MEETING WITH CONSUMERS POWER COMPANY ON JANUARY 16, 1980
REGARDING MIDLAND UNITS 1 AND 2 PLANT FILL

SUBJECT: SUMMARY OF DECEMBER 4, 1978 MEETING ON STRUCTURAL SETTLEMENTS

SUBJECT: REQUEST FOR ADDITIONAL INFORMATION REGARDING PLANT FILL

SUBJECT: Interagency Agreement No. NRC-03-79-167, Task No. 1 - Midland Plant
Units 1 and 2, Subtask No. 1 - Letter Report

Figure 37-1

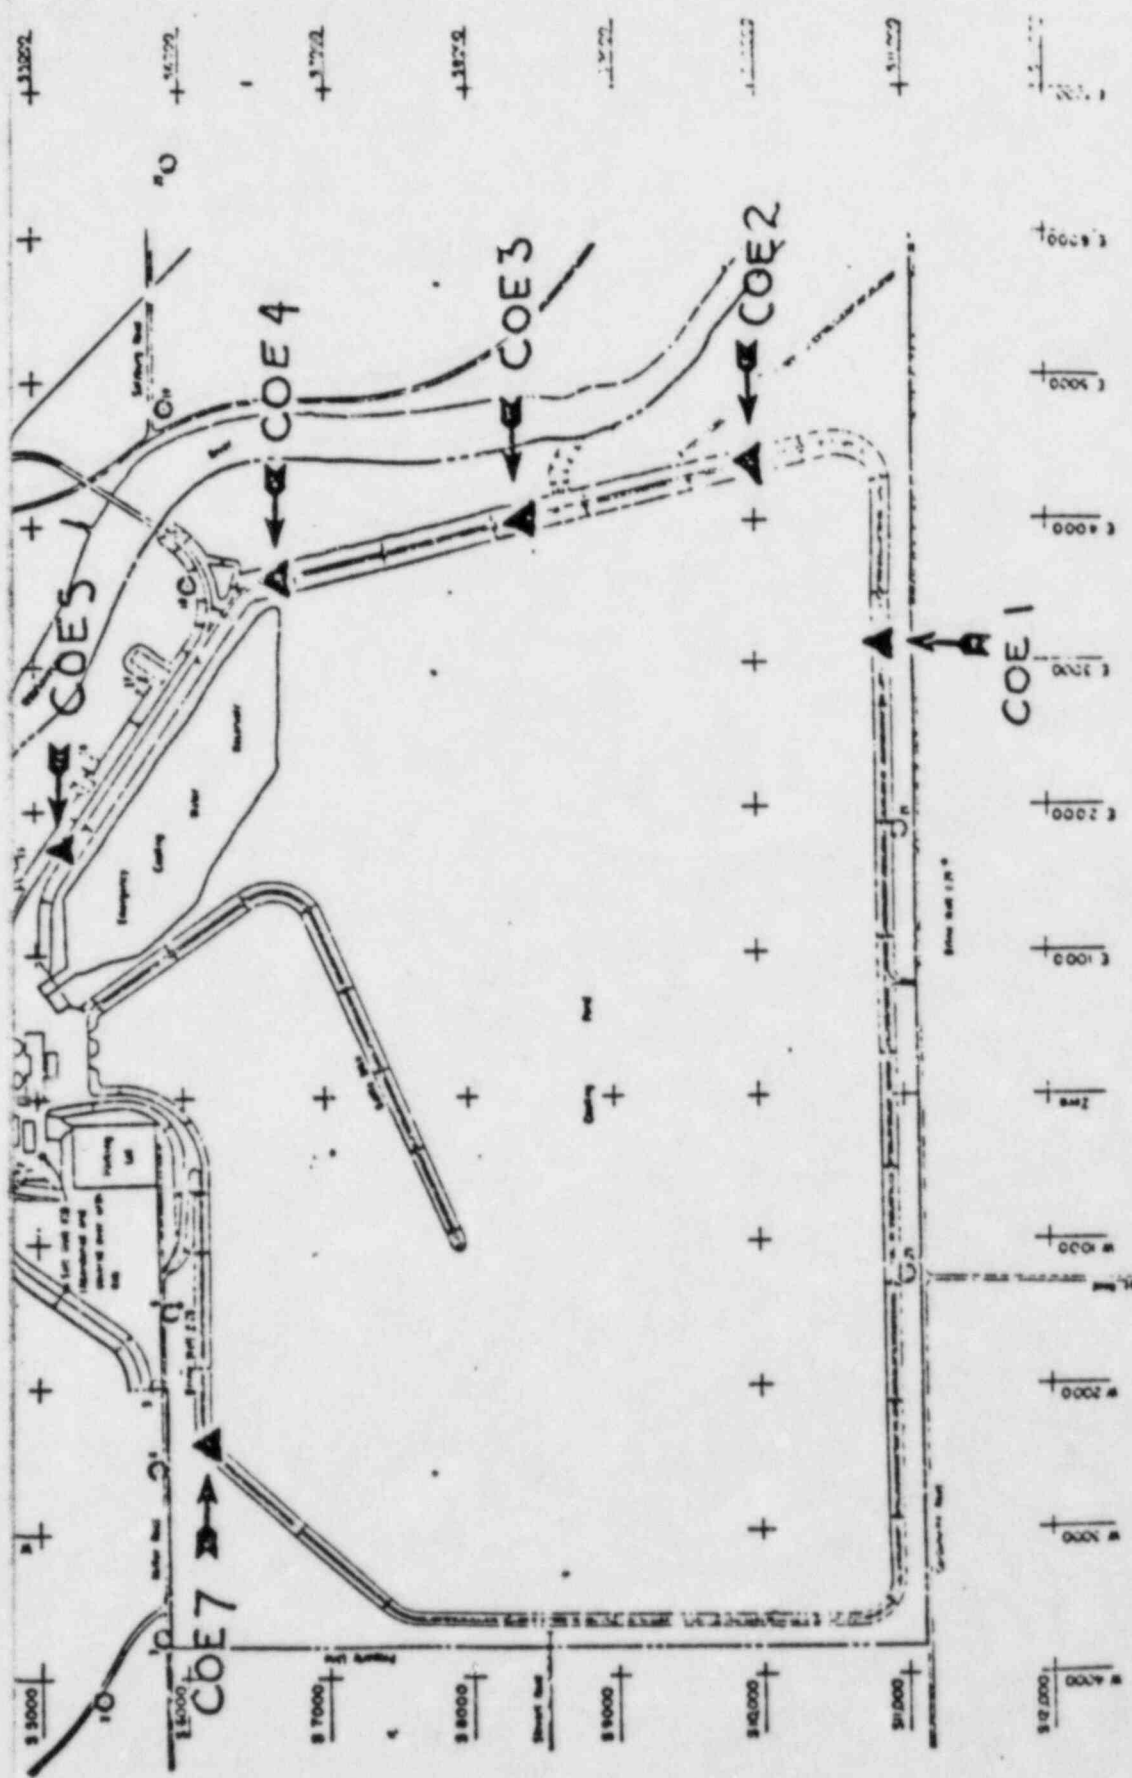
38. Discuss the foundation design for any seismic safety-related piping and conduit connected to or located under the Radwaste Building and Turbine Building where piping and conduit have been placed on plant fill.
